Bulletin No. 2002-12

## New Design - Lower Bow Arm Pin

All 01 and 07 Bow Mounts

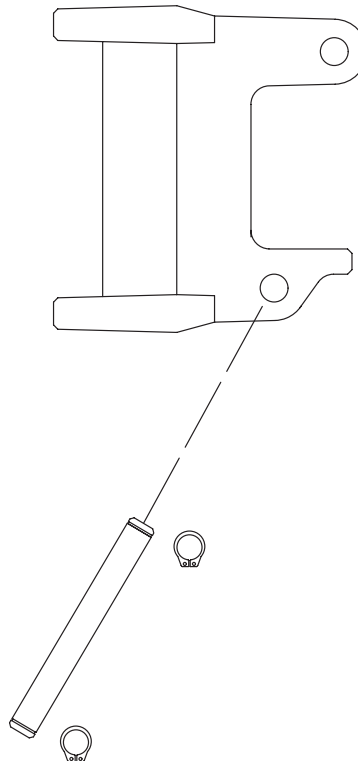
The lower bow arm pin that connects the bow arm to the bracket door assembly on all 01 and 07 bow mounts has been modified in order to ease assembly of the parts. The newly designed lower pin is similar, but not identical, to the upper pin. Both the pin and the retainer ring of the previous design, part numbers MBK04604 and 17-MBK10205, are No Longer Available (NLA).

The new design utilizes two snap rings in grooves located at each end of the pin. The previous design utilized a single retaining ring located further in from the end of the pin. (See Figure 2 below.)

**IMPORTANT: The old parts cannot be superseded to the new part numbers because the old and new parts must not be intermixed.**

Parts in your inventory may continue to be used. DO NOT mix parts of the old and new designs.

Qty. 1	17-MDK10703	Bow Arm Pin
Qty. 2	53-MRK04601	Retaining Ring
